Illinois Department of Transportation

SUBJECT: FAI Route 94/90
Project IM-094-3(397)055
Section (1818, ETC, 2324.6-1P)R-8
Cook County
Contract No. 62300
Item No. 1X, October 7, 2005 Letting
Addendum B

NOTICE TO PROSPECTIVE BIDDERS:

Attached is an addendum to the plans or proposal. This addendum involves revised and/or added material.

BALLAST DETAIL

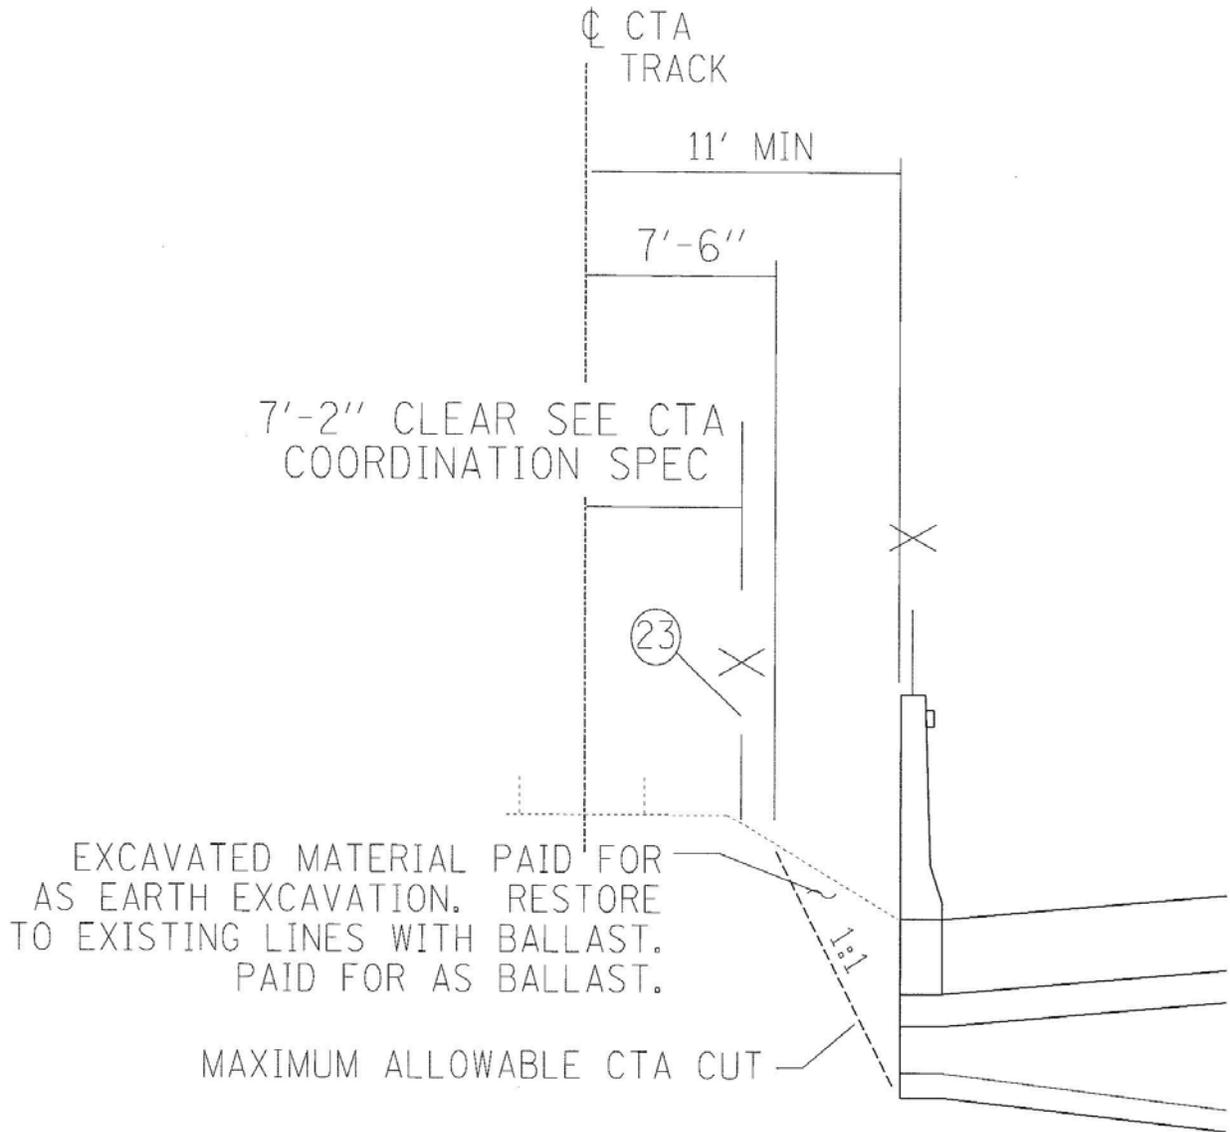
BALLAST

Ballast material shall be placed with mechanical spreader or spreader box or other device or method approved by the Engineer which shall minimize the working of the material and which must minimize the segregation of aggregates.

Ballast material shall be placed and compacted in layers not more than 6 inches compacted thickness.

Compaction of each ballast layer shall be by the operation tamping with a portable device. The Engineer shall determine the number of passes necessary to achieve an acceptable compaction. Excessive tamping of the ballast material which causes ballast particle breakage shall not be allowed.
